© 2015 Mazda Motor of America, Inc.

Subject: UNUSUAL NOISE WHEN STARTING TO MOVE VEHICLE WHILE STEERING WHEEL IS TURNED TO FULL LEFT POSITION	Bulletin No: 06-001/15
	Last Issued: 10/07/2015

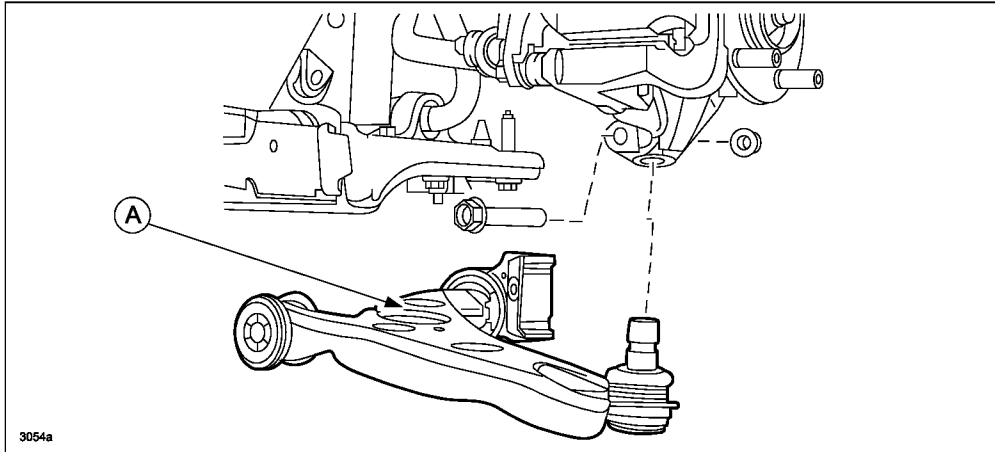
The noise is caused when the edge of the left side inner ball joint gets stuck with the steering gear housing.

To eliminate the noise, the shape of the inner ball joint edge has been changed.
